APPEAL SUMMARY

| Appeal ID: 33407 | Project Address: 3950 N Williams |
| Building/Business Name: Kiley40 | Fire Sprinklers: Yes - Whole building |
| Appeal Involves: Erection of a new structure, Reconsideration of appeal | LUR or Permit Application No.: 24-029720-CO |

B. SECTION

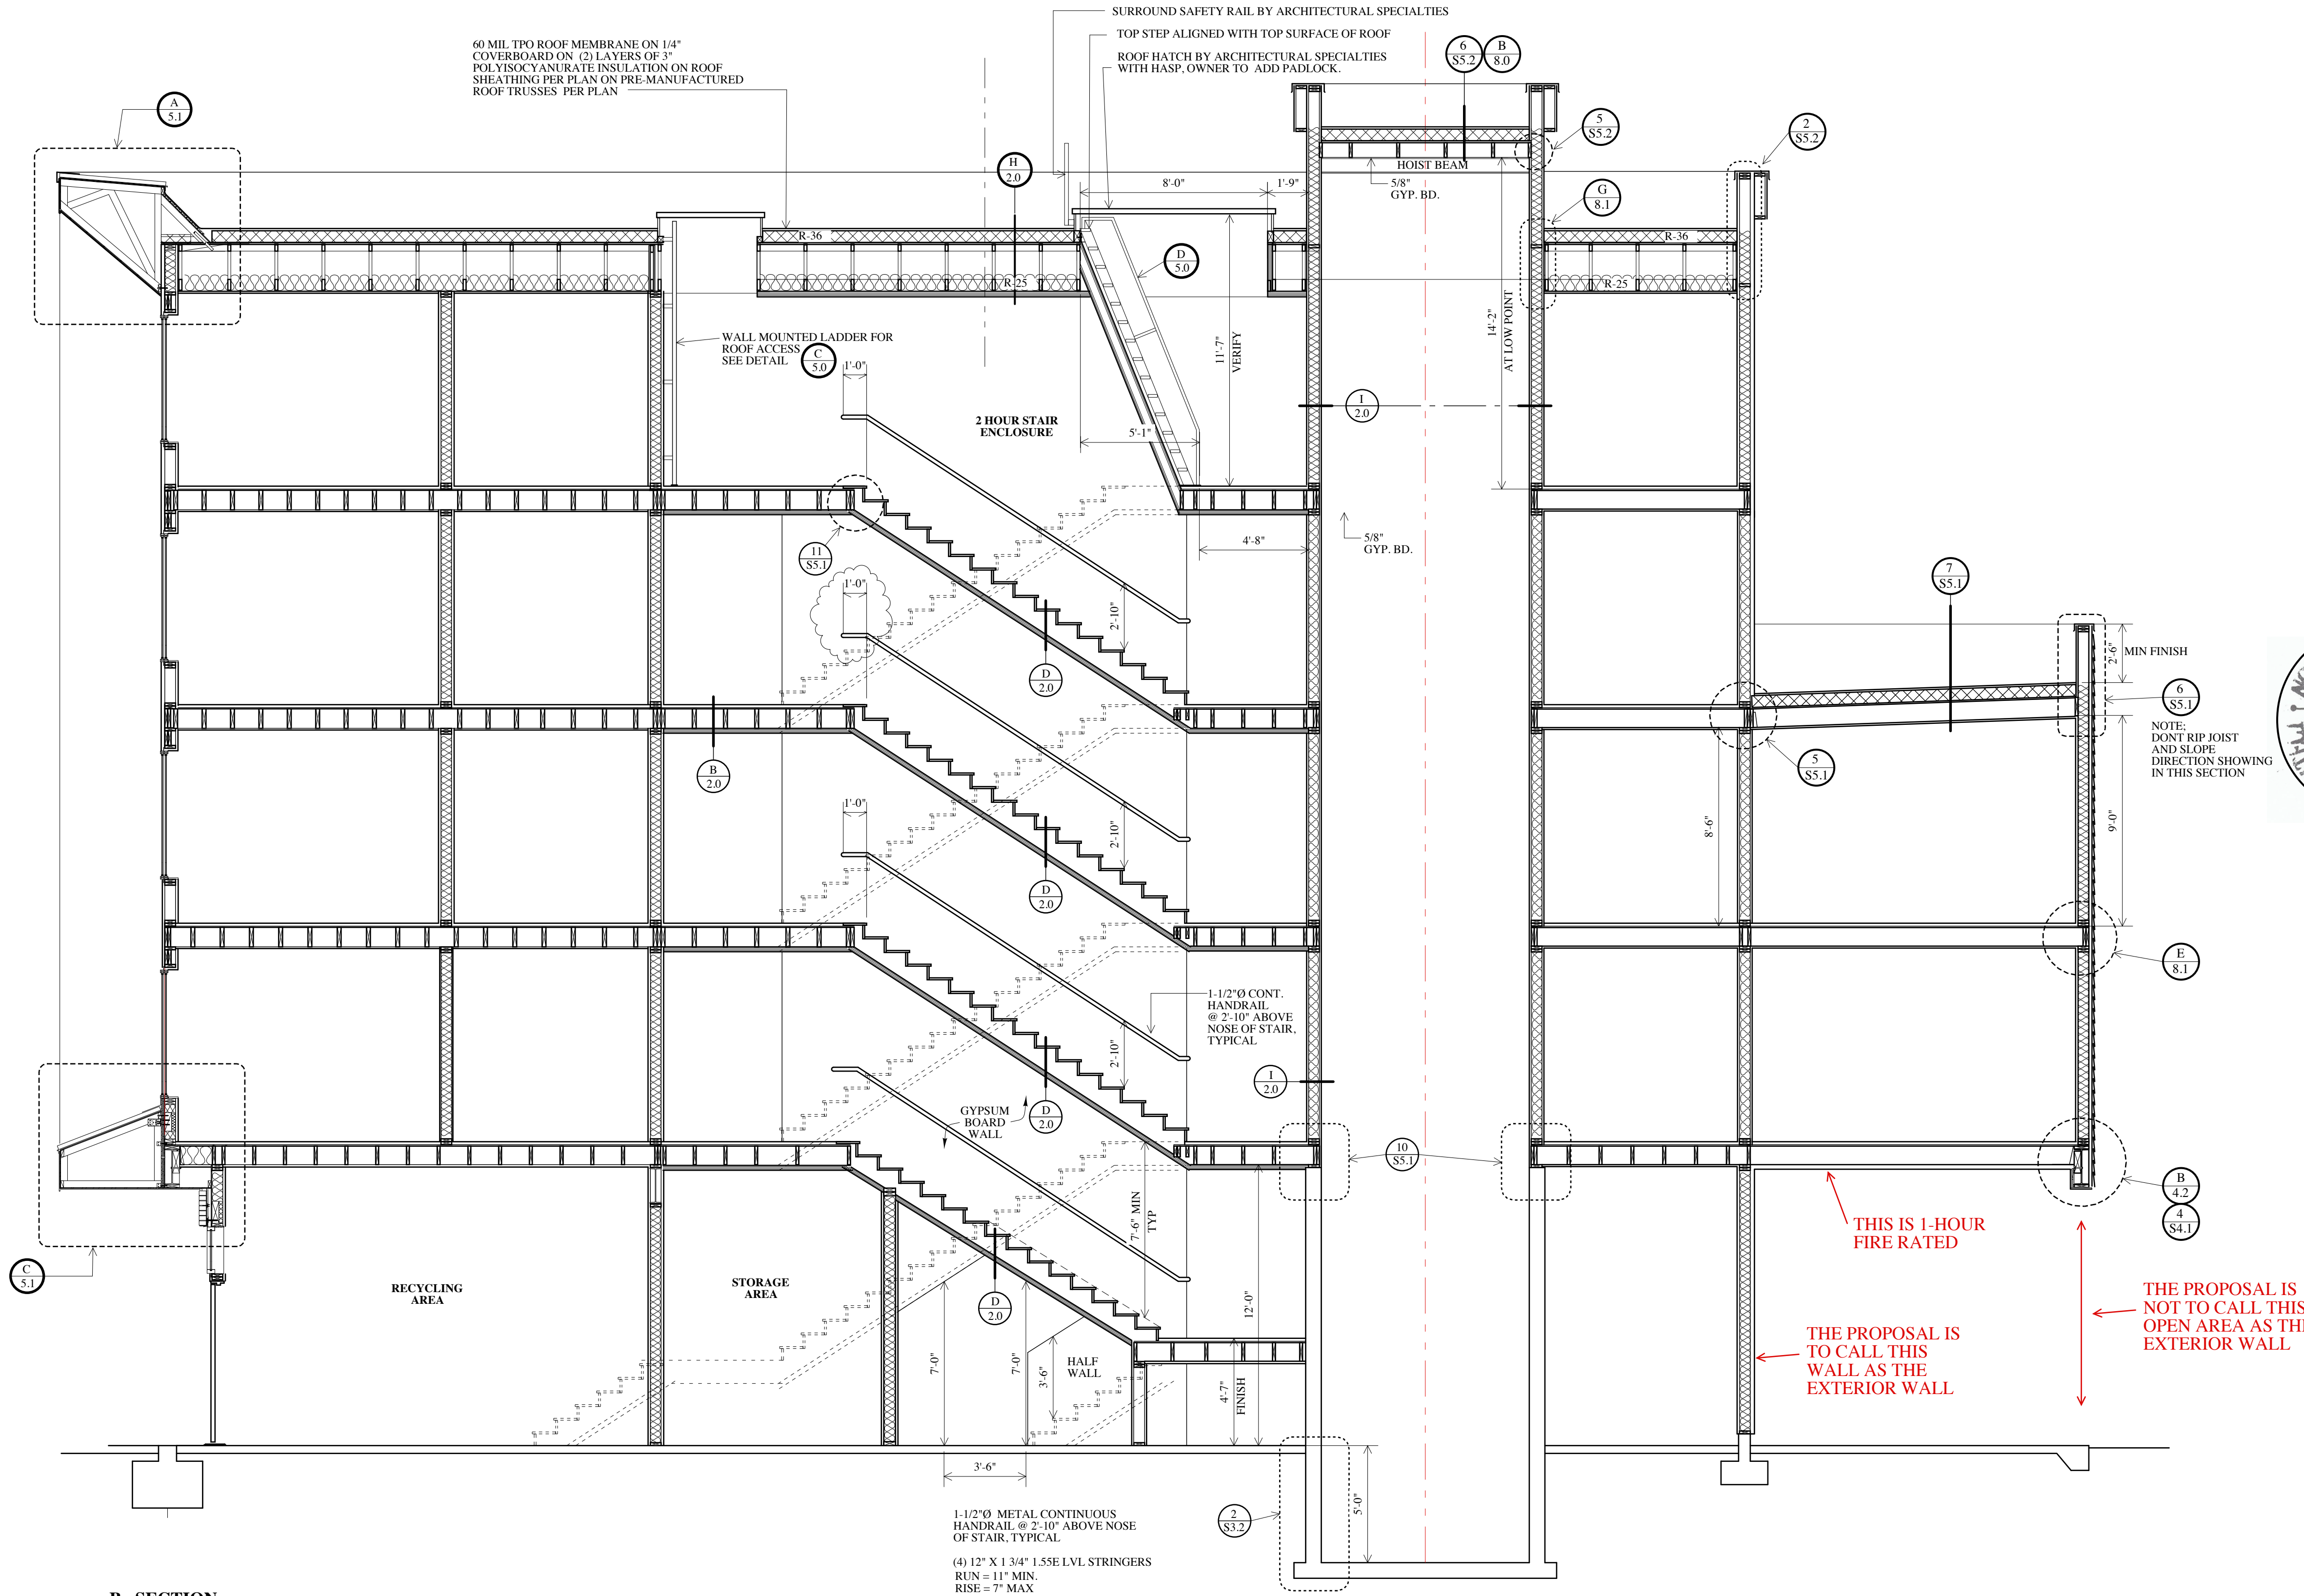
| Proposed Design | I will be using a 2-hour shaft assembly GA file #WP 7125 as the 2-hour assembly under a wood framed staircase to separate one stairway from another. You can see my stair section and details on attached sheet 8.1 and the assembly at detail K/2.0 |
